Office Memorandum • UNITED STATES GOVERNMENT

SUBJECT: TAILOR Transmitter Module Evaluation

FIG. I

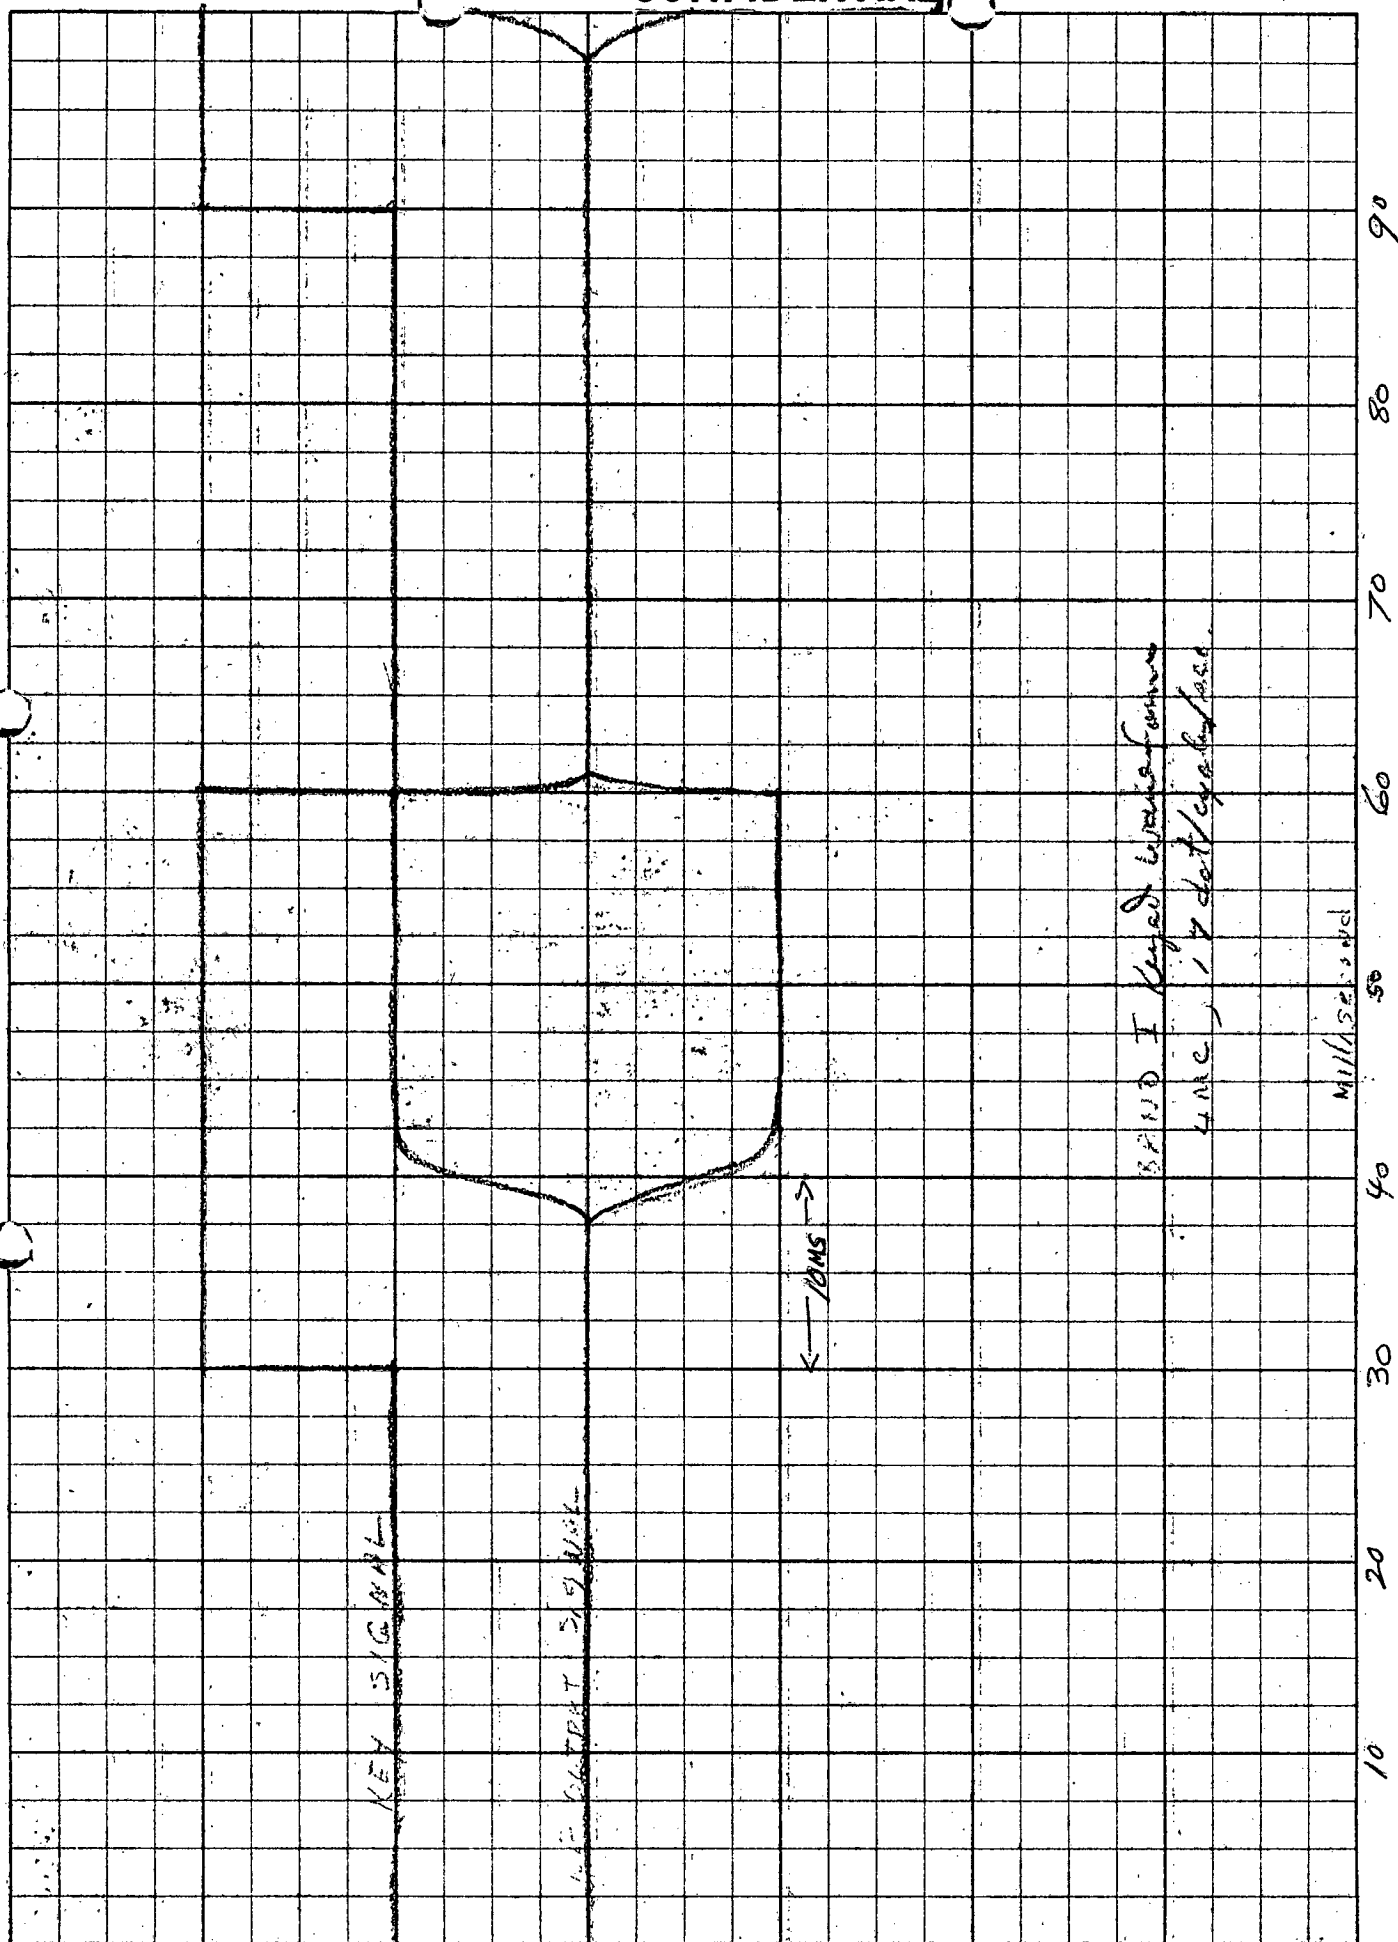
2. During the early phase of the evaluation, the test results showed serious shortcomings and as a result the tests were stopped. A summary of test data obtained, up to the time the tests were stopped, follow. Figures 1 and 2 show keyed waveforms typical of Bands I and III.

Keyed Waveform: Poor, 12 millisecond delay

Keyed Waveform: Poor, 12 millisecond delay
